Vista Del Agua - City Council Comment Letter No. 1

Mitchell M. Tsai, Attorney
Southwest Regional Council of Carpenters (2-26-2020)

RE: Vista Del Agua Specific Plan and Final Environmental Impact Report (SCH # 2015031003)

Figure 4: 2014 Statewide All Fleet Sizes (Pieces of Equipment)

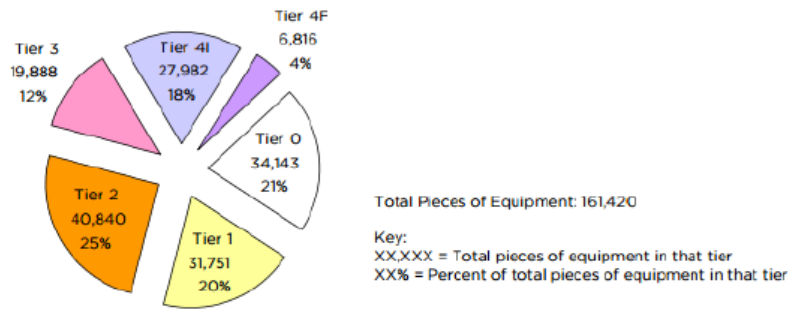
However, the EIR failed to evaluate the feasibility in obtaining Tier 4 Final equipment. Due to the limited amount of Tier 4 Final equipment available, the EIR should have assessed the feasibility in obtaining equipment with Tier 4 engines (see excerpt below).⁷

As demonstrated in the figure above, the Tier 4 Final equipment only account for 4% of all off-road equipment currently available in California. Thus, emissions are modeled assuming that the Project will be able to obtain Tier 4 Final equipment even though this equipment only accounts for 4% of available off-road equipment currently available in California. As a result, the model represents the best-case scenario even though obtaining this type of equipment may not be feasible. This is incorrect, as CEQA requires the most conservative analysis.

- 1.65 Figure 4 shows a graphic from 2014, before the mandatory requirements from the EPA and CARB for Tier 4 engines and BACT were fully enacted. Therefore, the data shown in this graphic is outdated and may not represent the current fleet engine usage mix. Tier 4 engine demand continues to expand each year and contractors are upgrading their fleets to meet the demand. No further response required.
